SUBJECT: Donald C. Cook Nuclear Plant Unit 1
Docket No. 50-315
Response to Request for Additional Information Regarding the Reanalysis of Unit 1
Small Break Loss-of-Coolant Accident

Enclosure 1 to AEP:NRC:8046

Figure 6-9
Total Core Liquid Mass
(2.75-inch break)

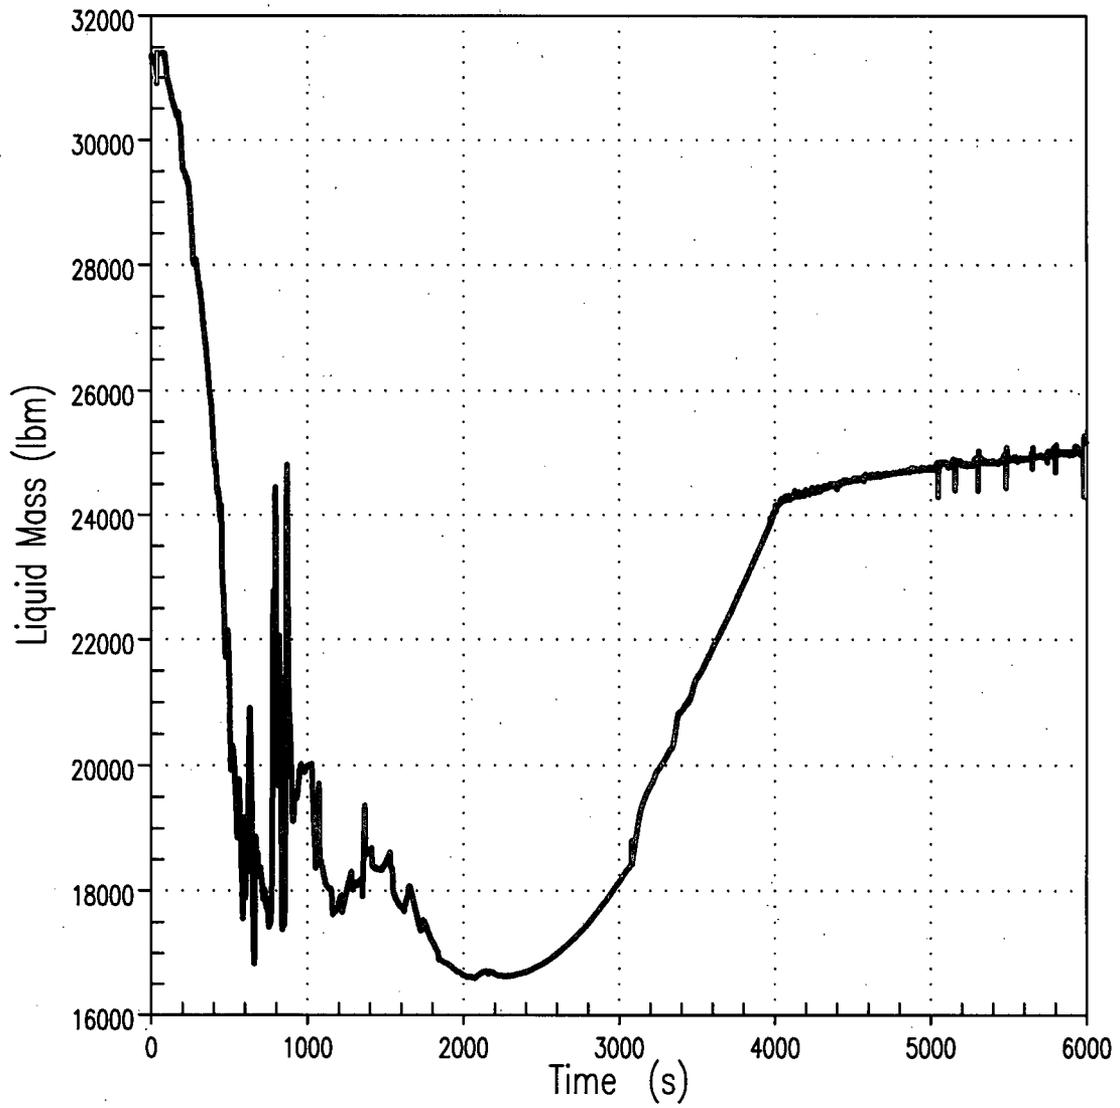
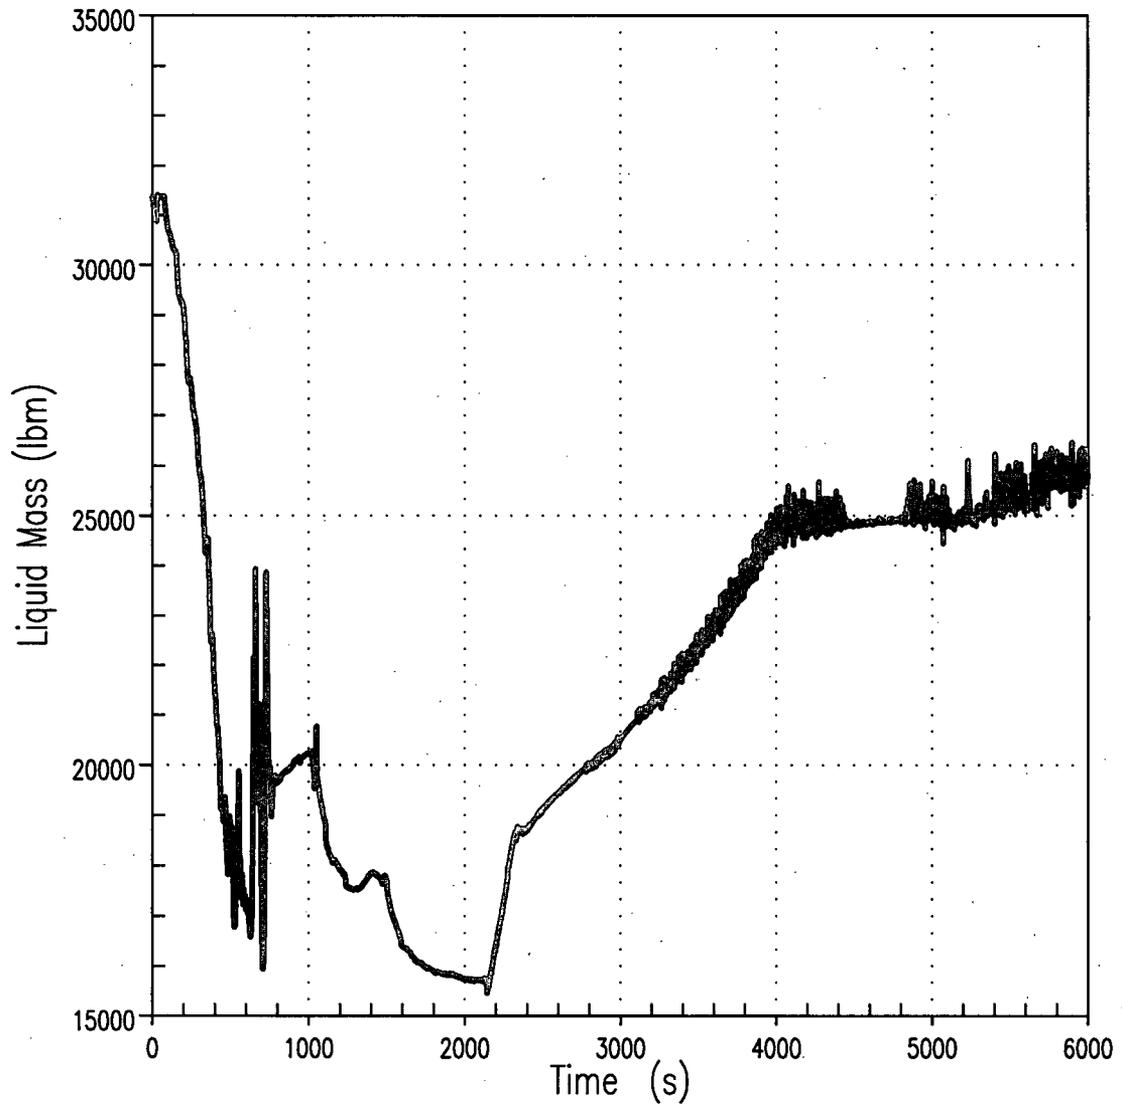
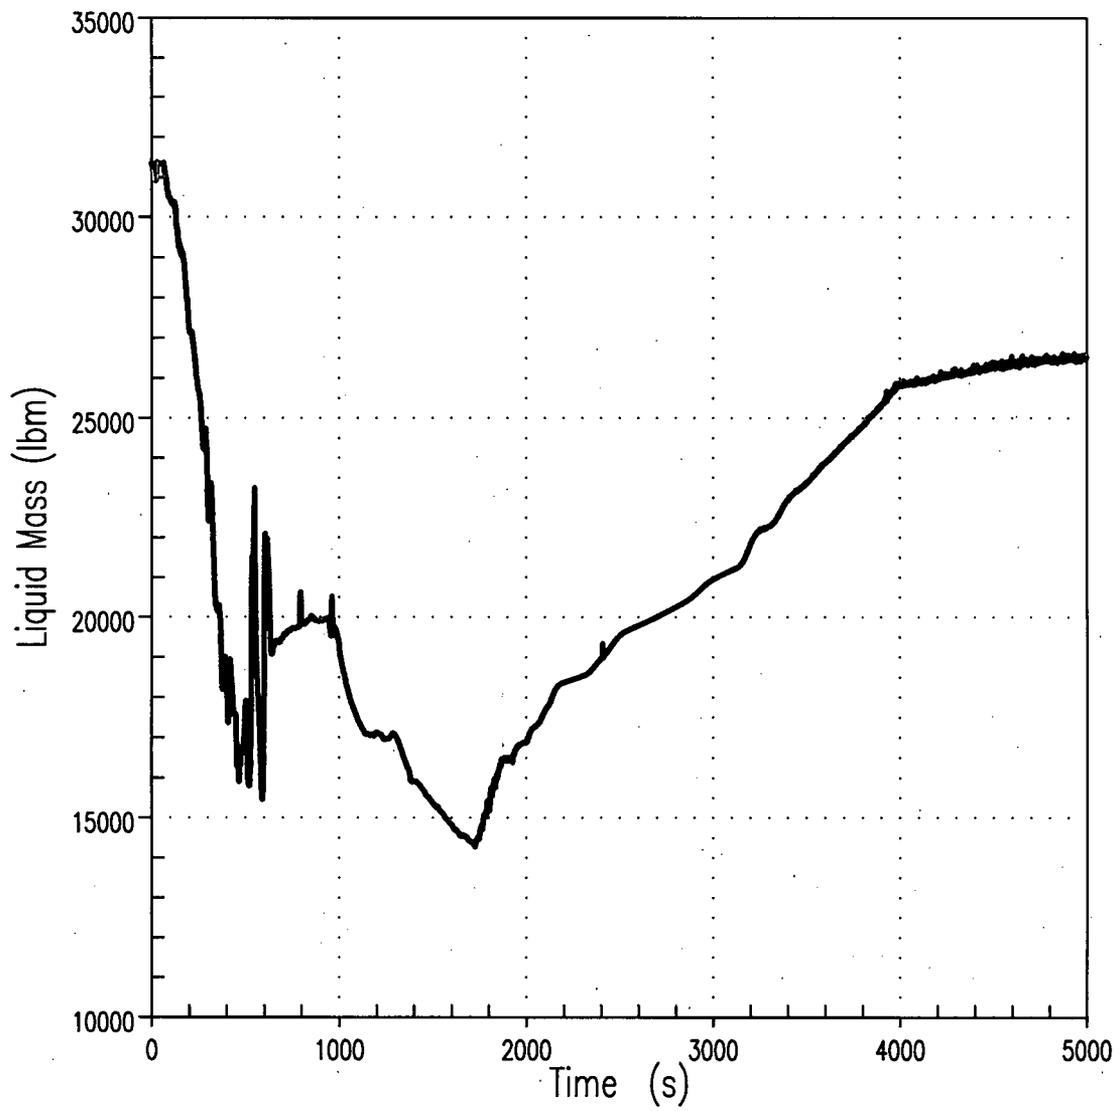
Please explain the termination in the core two-phase level for the 3-inch break from 1000 to 1300 seconds in Fig. 28 for the 3-inch break. The 2.5-inch break has a similar behavior from 1200 to 1500 seconds in Fig. 25 as does the 2.5-inch break from 1100 to 1600 seconds in Fig. 22. Please explain the abrupt deviation from the boil-down and initial rapid loss of level behavior for these breaks. The froth-up behavior for the 2.5-inch break terminates and cools the hot spot during this period and does not appear physical. Please also provide the liquid mass and core inlet flow rates vs. time for these breaks.

The core mixture level termination seen in the 2.5-, 2.75-, and 3-inch breaks can be attributed to the steady decrease in pressure differential between the UP and the DC at the same time, as seen for the 3-inch break case in Figure 6-1. A similar behavior also occurs for both the 2.5- and 2.75-inch breaks. Note that, as the break size decreases, this differential pressure effect becomes more pronounced as can be seen in Figures 6-2 for the 2.5-inch case and Figures 6-3 for the 2.75-inch case.

The froth up behavior seen at 1400 seconds in the 2.5-inch break case can be attributed to the mixture level variations during that time which causes a corresponding peak in the PCT at this time as seen in Figure 6-4.

The core inlet flow rates versus time for the 2.5-, 2.75-, and 3-inch breaks are provided in Figures 6-5, 6-6, and 6-7, respectively. The total core liquid mass for the 2.5-, 2.75-, and 3-inch breaks are provided in Figures 6-8, 6-9, and 6-10, respectively.

Figure 9-1

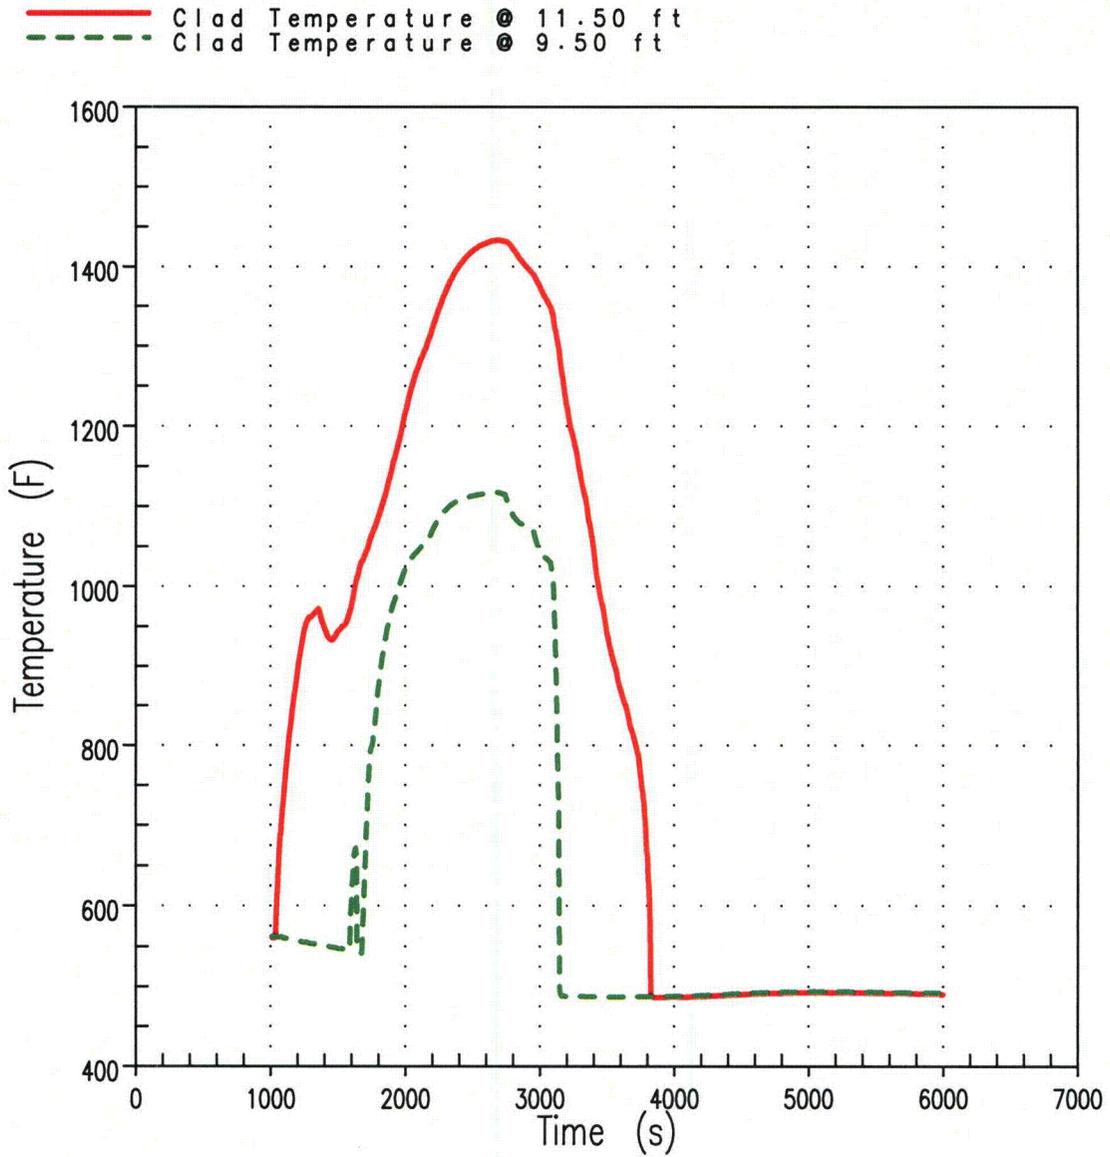
Please explain why the hot spot location at 9.5 feet does not produce the highest PCT and rupture location, since Table 5 identifies the PCT elevation as 11.75 ft, which has a local linear power level of about 6 kw/ft versus 12.5 kw/ft at 9.5 ft.

For the 3.25-inch break case the hot rod PCT occurs at 1480 seconds when the mixture level is about 17.6 feet, (approximately 7.6 feet above the bottom of core). The core region above the quench front is exposed to vapor, with higher vapor temperatures at higher elevations. Therefore, the higher the elevation from the core mixture level the larger the integrated core heat up rate, due to less heat being removed at these elevations. This, in turn, results in higher clad temperatures at the higher elevations. This is illustrated in Figure 9-1, where the hot rod clad temperatures at 11.5 feet are higher than at 9.5 feet, indicating that the PCT elevation is more a function of vapor temperature and is less affected by the local linear power level at that elevation.
